This evaluation was undertaken in response to suggestions from Bechtel QA and Geotech that the Troxler Nuclear Guage was responsible for field density tests plotting outside the zero-air-void curve on moisture-density plots of cohesive fill placed in the Midland plant area. It was felt that the initial studies which resulted in approval of the Troxler might give some indication of its accuracy. Primary reference is Item "I" attached to a letter from K. Rademacher of U. S. Testing Co. to E. Felton of Bechtel, dated 5/30/74, (see Appendix A).

MIDLAND PROJECT
JOB 7220-101
PLANT AREA FILL

ANALYSIS OF MIDLAND PLANT AREA FILL

FIG. 1:

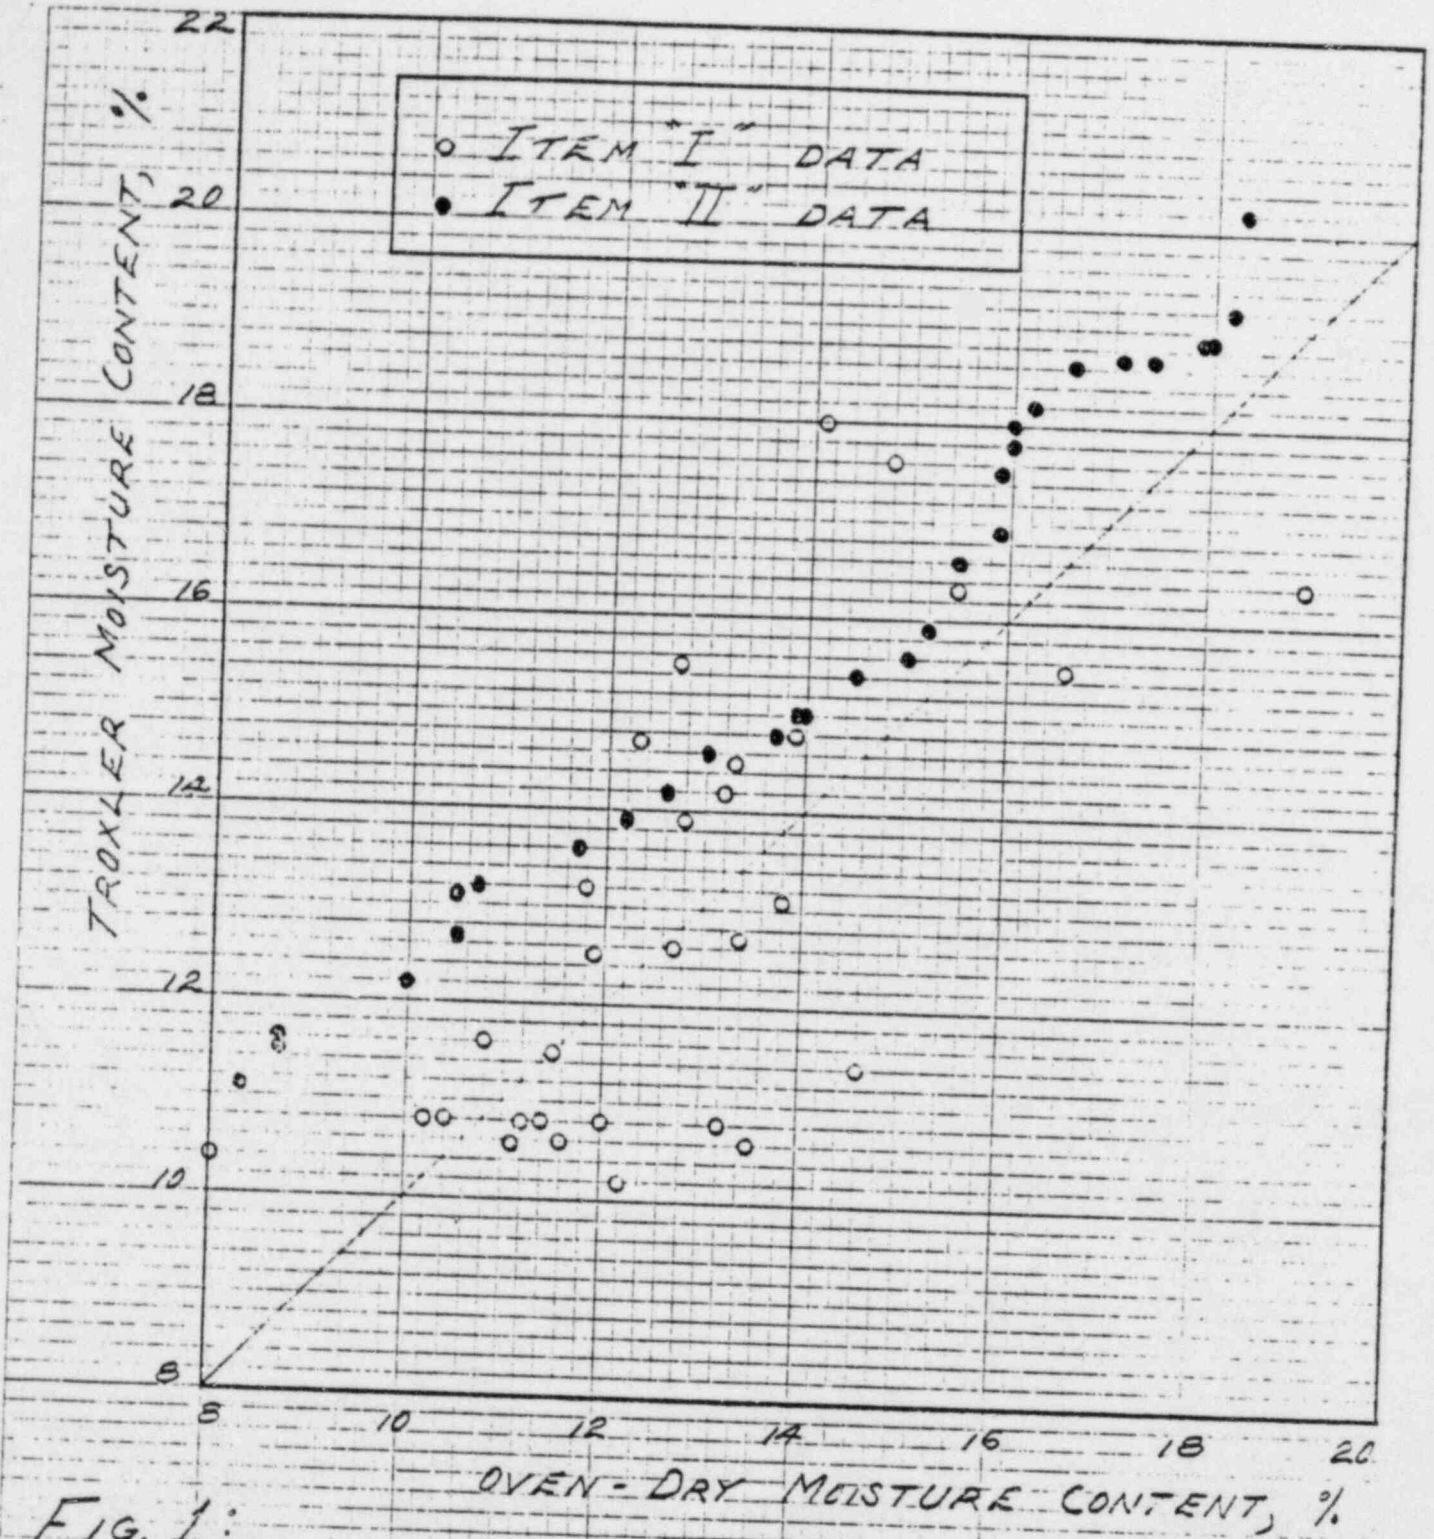
In evaluating the second finding, again arithmetic errors were found in the U. S. Testing report. However, as the correlation of .98 was ~~apparently~~ not calculated for the same data as shown in Item "I" nor did it appear reasonable based on the broad scatter of the data shown in the attached graph, the coefficient was recalculated. (see Fig. 1)

A correlation coefficient of .637 would indicate a moderate relationship at best between the Troxler and oven-dry methods. In addition, the standard error of estimate indicates that 95% of all Troxler values will be within $\pm 3.6\%$ of the oven dry, 68% with $\pm 1.8\%$. This in turn means that errors of ± 5 pcf can be anticipated in dry density calculations based on the Troxler moisture determination.

Note that the second set of data which was used for computation of the .98 correlation coefficient has an average deviation of +1.6% for the Troxler, indicating that a correction factor would be required. Again assuming the regression curve to be a 45° line through the origin, then the standard error of estimate for this data (after correcting arithmetic errors) is 1.842 and the correlation coefficient is .719. If a correction factor of -1.6% is applied to all Troxler values, the standard error of estimate drops to 0.686 and the correlation coefficient becomes .966, which would have been somewhat more acceptable. U.S. Testing did not do this however.

Thus the conclusion here is that the Troxler nuclear densometer was not accurate enough for use in field moisture determination and that the U.S. Testing findings did not properly represent the condition of the data.

FIGURE 7-A.

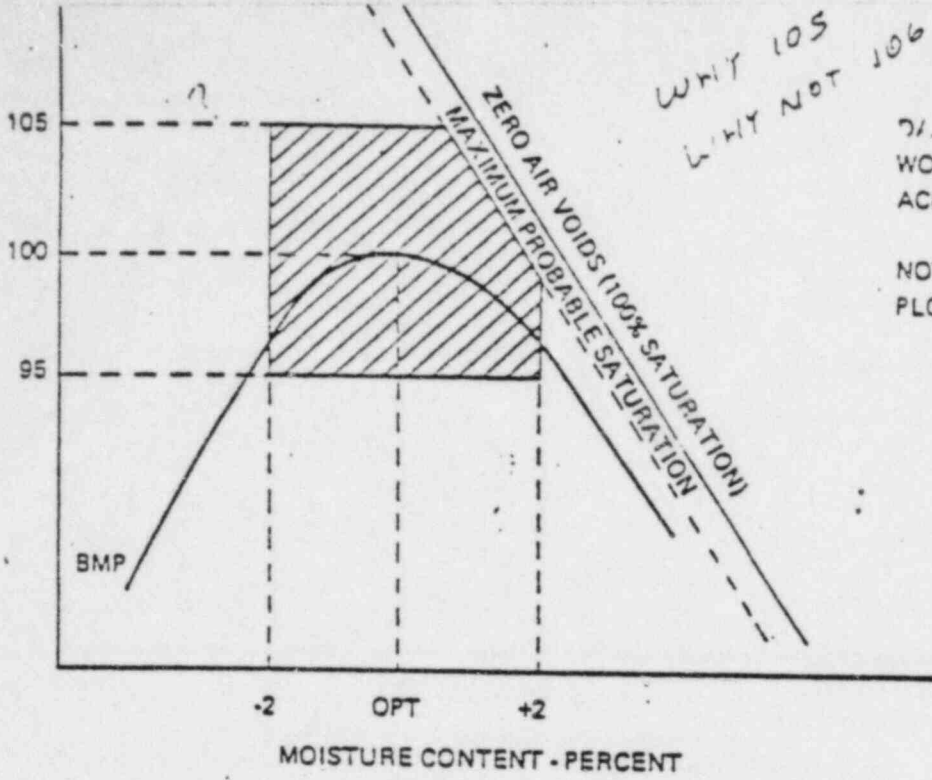
For a field test result to be classified as "Passing" it must fall within a well defined area on the plot containing the laboratory compaction curve. This area or window of acceptability is shown for a hypothetical compaction curve on figure 7a that would meet requirements of Specification 7220-C-210. It is defined by horizontal lines at 95 percent and 105 percent of specified density, vertical lines through ± 2 percent of optimum moisture content, and a line parallel to the zero air voids line indicating saturation about half way between the compaction curve and 100 percent saturation (zero air voids curve). If all data points fall within this area there would be no reason to assume that they are wrong. However, when many data points fall outside the designated area there is something wrong with the information and then all data points become suspect. A review of all data indicates that only about 25 percent of the cohesive soil test results fall within this area.

FIGURE 7-B.

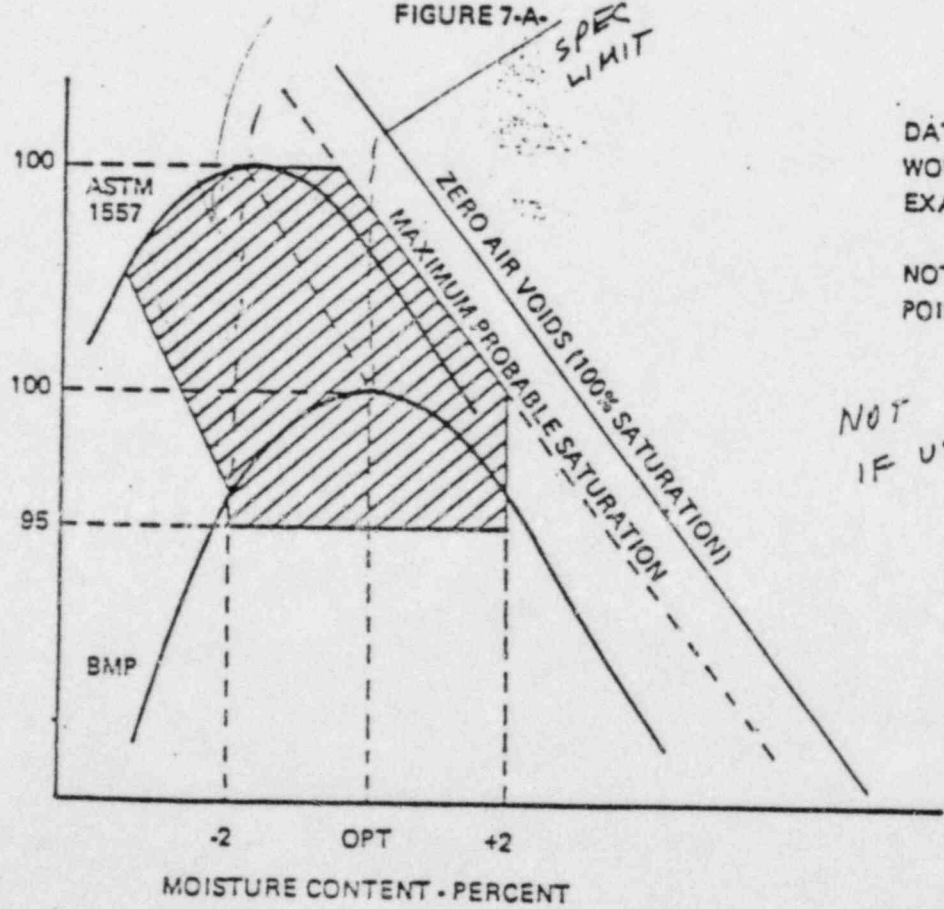
Figure 7b shows an area where field test results would be acceptable even though not in strict accordance with the specifications. Figure 7b was arrived at by expanding figure 7a to include test results up to a compactive effort related to ASTM D 1557 (56, 255 ft.-lbs./ft.³) which is considered to be a practical upper limit. About 40 percent of all field test results would plot in this area.
